COUNCIL ASSESSMENT REPORT

Panel Reference	PPSSNH-28
DA Number	DA.255/19
LGA	North Sydney
Proposed Development	Demolition of existing buildings, excavation, and construction of a part 4 part 6 storey residential flat building.
Street Address	147, 151 and 153 Kurraba Road, Kurraba Point
Applicant/Owner	Thirdi Kurraba Pty Ltd / Multiple Owners (SP129, SP400586, and SP22851)
Date of DA lodgement	26 August 2019
Number of Submissions	Original Plans: 134 (58 Object, 76 Support) Amended Plans: 75 (33 Object, 42 Support)
Recommendation	Approval
Regional Development Criteria (Schedule 7 of the SEPP (State and Regional Development) 2011)	Capital Investment Value (CIV) exceeds \$30 Million
List of all relevant s4.15(1)(a) matters	<ul style="list-style-type: none"> • SREP (Sydney Harbour Catchment) 2005 (Site is located within the Sydney Opera House Buffer Zone – Clause 58A of the SREP) • SEPP (Infrastructure) 2007 • SEPP (State and Regional Development) 2011 • SEPP No. 55 – Remediation of Land and draft Remediation SEPP • SEPP No.65 – Design Quality of Residential Apartment Development) • SEPP (Building Sustainability Index – BASIX) 2004 • SEPP (Vegetation in Non-Rural Areas) 2017 • Draft SEP

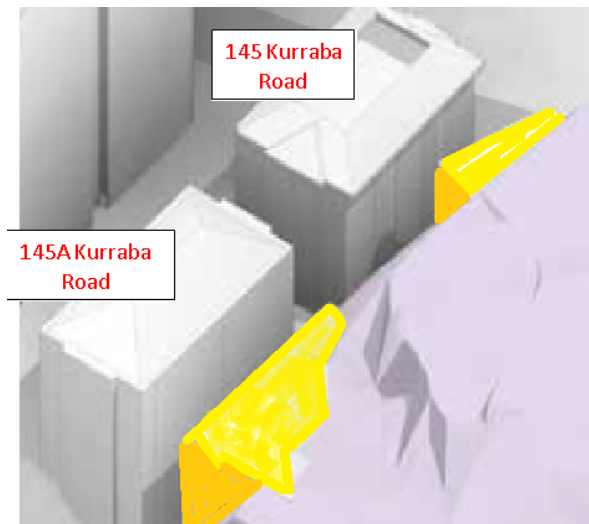
Yes	<p><u>Public Realm: Hodgsons Lookout Park</u> The proposed development will cast some additional shadows over Hodgkins lookout park to the south of the site however the additional shadows are not significant with 83% of the park or more receiving solar access between 9 am and 3pm midwinter, refer to Figure 6 below. The impacts to the park are not significant and are acceptable.</p> <div data-bbox="611 1655 1445 2036">  </div>

<p>Existing – 12 midday (8.1% of park in shade)</p>  <p>Existing – 1pm (8.9% of park in shade)</p>  <p>Existing – 2pm (10.2% of park in shade)</p>  <p>Existing – 3pm (14.4% of park in shade)</p> 	<p>Proposed – 12 midday (8.6% of park in shade)</p>  <p>Proposed – 1pm (12.4% of park in shade)</p>  <p>Proposed – 2pm (11.8% of park in shade)</p>  <p>Proposed – 3pm (16.6% of park in shade)</p>  <p>Figure 6: Midwinter solar access impact for park</p> <p><u>Public Realm: Kurraba Reserve</u> Shadows falling across Kurraba Reserve will be comparable to existing, limited to the morning hours only, and will fall across a cliff face and vegetation rather than any useable part of the reserve. The impacts are negligible.</p> <p><u>Future occupants</u> As detailed in the ADG compliance table earlier within this report, 60% of the proposed apartments will receive 2 hours of solar access during the winter solstice, non-compliant with the required 70%, but this is acceptable on balance given the large size of the apartments, the views many of the apartments will experience, the dual aspect nature of apartments and the compliant or exceeding compliant provision of private amenity space. Overall the apartments offer a level of amenity which offsets the non-compliance.</p>

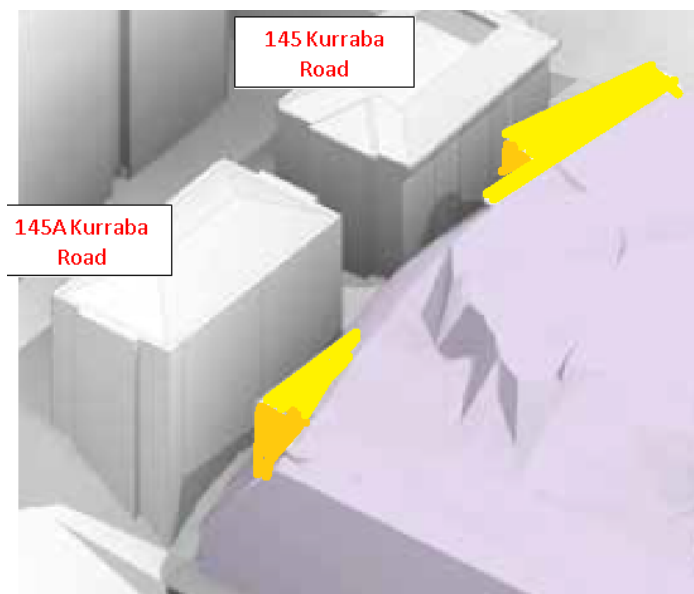
1.4 Quality built form		
Context and Streetscape	Yes	<p>The site layout responds to the constraints of the site and as a result neighbor amenity impacts are minimised. The proposed building orientation and setbacks are acceptable as discussed throughout this report, and adequate space is available for landscaping, including along site boundaries. Tree removal is proposed; however, the trees to be removed generally have a low retention value, and significant</p>

replacement tree planting is proposed within the landscaping scheme. The application was amended to provide lower and more appropriate boundary treatment to ensure there will be opportunity for passive surveillance of the public realm around the site.																														
Subdivision Pattern	Yes	The development proposes the consolidation of three titles resulting in one larger development site (refer to Condition G22). The resultant development site is larger than some of the properties in the immediate vicinity however it is comparable in size to other sites in the locality including 143 Kurraba Road to the north. The development proposes a modulated built form along Kurraba Road to reflect the existing subdivision pattern and break up the massing.																														
Streetscape	Yes	Generally, the development provides a high-quality street edge with the provision of landscaping and generally low front boundary treatment, comprising high quality materials (red brick and re-purposed sandstone blocks). Conditions are proposed to ensure that Council's infrastructure and footpaths are not damaged (refer to Conditions C19 and C24).																														
Siting	Yes	The proposed development generally maintains the characteristic building orientation and siting.																														
Setback – Front	Yes	<p>NSDCP states that the front setback must match the alignment of the primary facades of buildings on adjoining properties. The site is located at a curve in the road and has no neighbours to the south, therefore the front setback of the neighboring building to the north (145 Kurraba Road) is to be considered in assessing the proposed front setback. The face of that building has a front setback of between 3.5m (north side of building) and 5.3m (south side) from its street (east) boundary equating to an average setback of some 4.40m (refer to Figure 7).</p> <p>The proposed northeastern part of the development where it adjoins 145 Kurraba Road provides a front setback of between 4.28m (northernmost balconies) and 6.5m (face of the building) which is considered appropriate and consistent with the established setback provided by 145 Kurraba Road.</p> <p>The front setback of the remainder of the building ranges from 3.2 to 4.5m from the front (eastern/southern) boundary, which is considered acceptable given the size of the site, the curved frontage, and the lack of any buildings adjacent to the southwestern tip of the site.</p>																														
Setback – Side	No (acceptable on merit)	<p>The objectives of the setback controls are set out in Part B Section 1.4.6 in NSDCP and aim to reinforce the characteristic pattern of setbacks and building orientation, to control the scale and bulk of buildings, to provide adequate building separation, and to provide amenity for existing and new dwellings in terms of solar access, views, and ventilation.</p> <p>The performance of the proposal against the setback controls is set out in the below table and discussed below.</p>
